#38 – Comments on DNRs “100% Study”

Figure 1

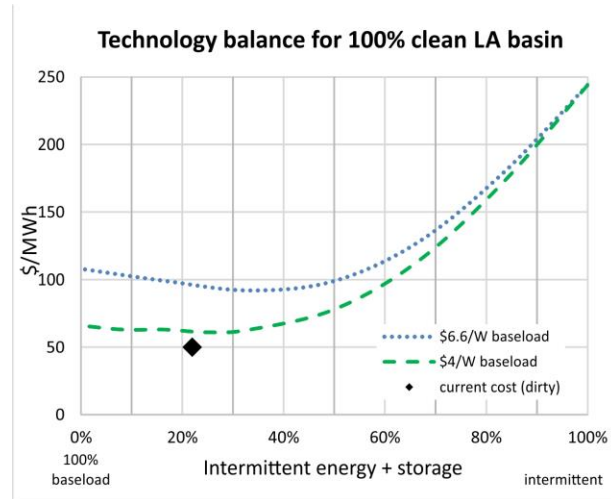
Fig.1 is adapted from a [validation study](#) we conducted of [LA-100](#), a large NREL study of 100% renewables for the LA-basin. The chart presents system generation cost (\$/MWh) as a function of % of energy

delivered by generic wind/PV/baseload+storage capacity. 100% baseload is on the left, 100% wind/PV is on the right. The dotted line represents the minimum cost combination of wind + PV for a baseload CAPEX of \$6.6/W, the dashed curve \$4/W. The former is NREL-AB estimates for Gen 3+ nuclear. The latter is our estimate for Gen 4 SMRs based on international experience. NREL assumed ethanol combustion turbines for renewable energy baseload.

The most salient conclusion is that the low-cost system configurations are on the left, high baseload capacity, low intermittent generation capacity. This confirms Sepulveda, low-cost 100% clean system configurations need baseload. Minimum system generation cost occurs at about 35%/65% intermittent/baseload. Beyond 35-40% system costs hockey stick, 100% wind/PV is impractical. Another notable observation (not apparent on the chart) is that for the numbers used, wind reduced system cost only at >80% intermittent energy. Below 80%, wind always added cost and is not a useful component of a low-cost system. It is also notable that cost estimates at >50% intermittent penetration are soft, likely low, perhaps by a lot. The analysis uses NREL-ATB 2033 cost estimates for 4-hour storage. For intermittent energy scenarios >50% penetration, much longer durations would be required.

Fig.1 based on the LA-100 [system model validation](#) shows the system cost relationship between baseload and intermittent generation. An important lesson is the hockey stick nature of system costs. Intermittent generation can be integrated with little impact on total system costs up to a certain threshold. Beyond that threshold out-of-market costs (transmission, storage, curtailment) to manage intermittency drive overall system costs. For the LA basin with good PV the low-cost optimum is approximately 35% PV + 65% baseload. So where is the threshold for Maryland?
